UNITED STATES PATENT AND TRADEMARK OFFICE

| APPLICATION NO. | FILING DATE | FIRST NAMED INVENTOR | ATTORNEY DOCKET NO. | CONFIRMATION NO. |
|-----------------|-------------|----------------------|---------------------|------------------|
| 09/848,819      | 05/03/2001  | Richard T. Allen     | ACS 57527           | 8480             |

# Office Action Summary

## **DETAILED ACTION**

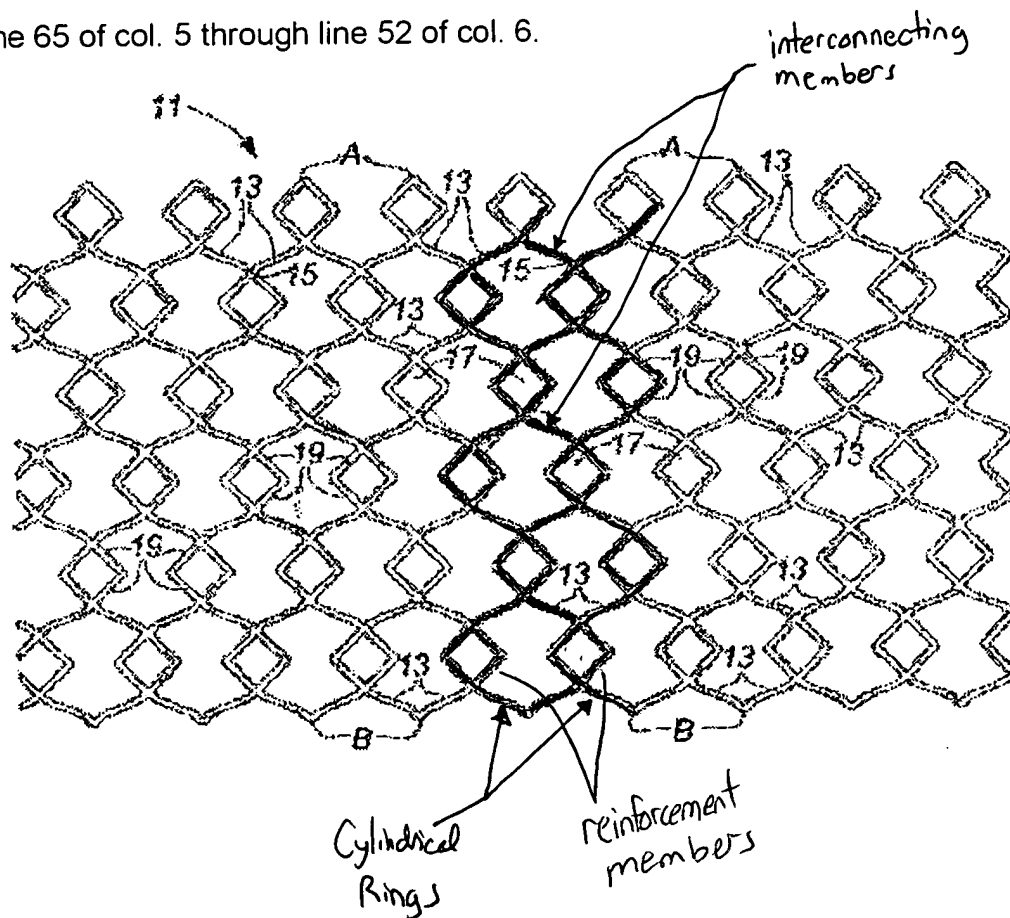
2. Claims 1,2,6,11,15-19, and 21 are rejected under 35 U.S.C. 102(e) as being anticipated by Milo US PN 6,206,911.

See figure 1 inserted below specifically showing location of the cylindrical rings, reinforcing members, and interconnecting members in figure 1. Also see lines 26-54 of col. 3 and line 65 of col. 5 through line 52 of col. 6.

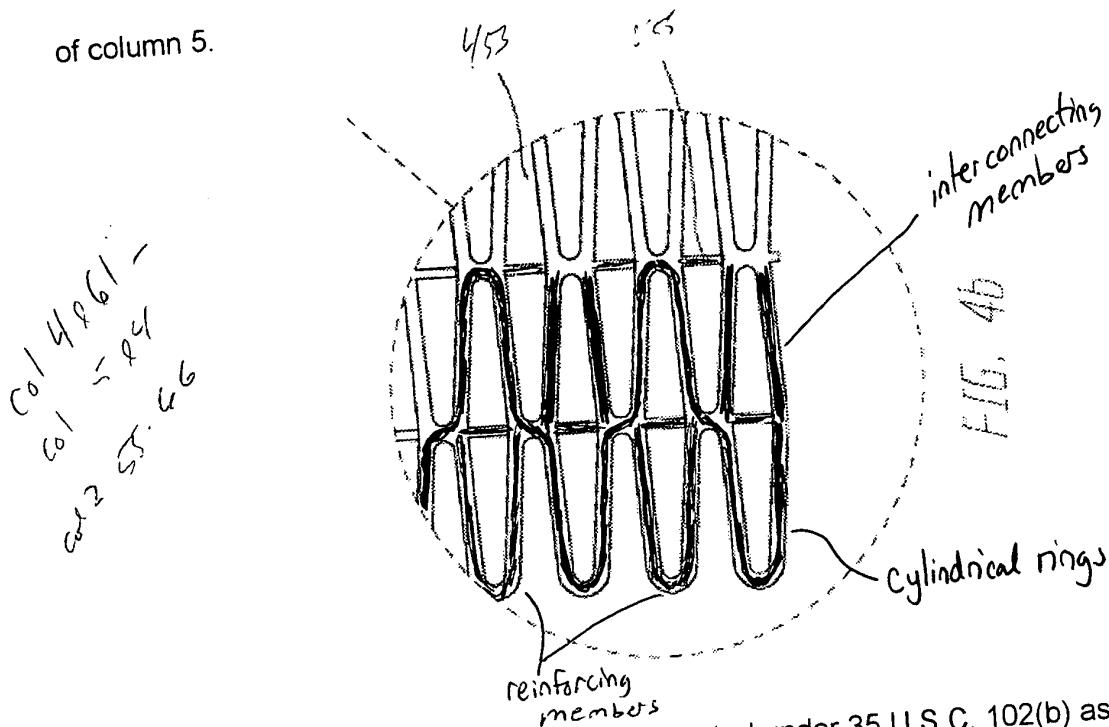
3. Claims 1,2,4,10,11,15,16,18,19, and 21 are rejected under 35 U.S.C. 102(e) as being anticipated by Killion US PN 5,868,781.

See figure 4b below specifically showing location of the cylindrical rings, reinforcing members, and interconnecting members in figure 4B. Also see lines 16-27 of column 5.

【圖11】

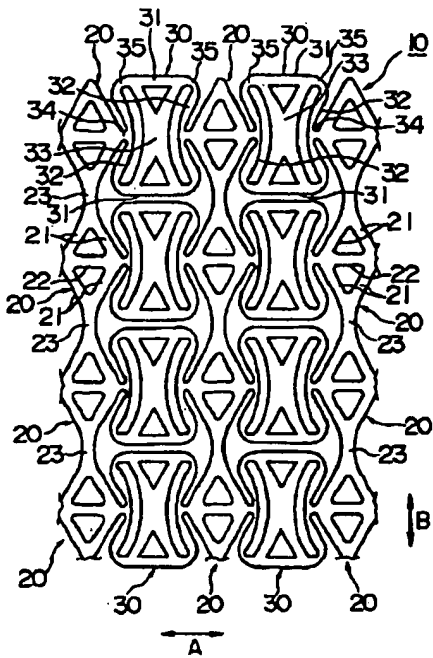
4. Claims 1,4,6,10,11,18, and 19 are rejected under 35 U.S.C. 102(b) as being anticipated by Hiroyuki et al. JP 10201856 A.

Hiroyuki et al. discloses a stent in figures 11-12 meeting the structural limitations of claims 1,4,6,10,11,18, and 19. See the attached figures 11-12 showing specific locations of the cylindrical rings, interconnecting members, and reinforcing members.
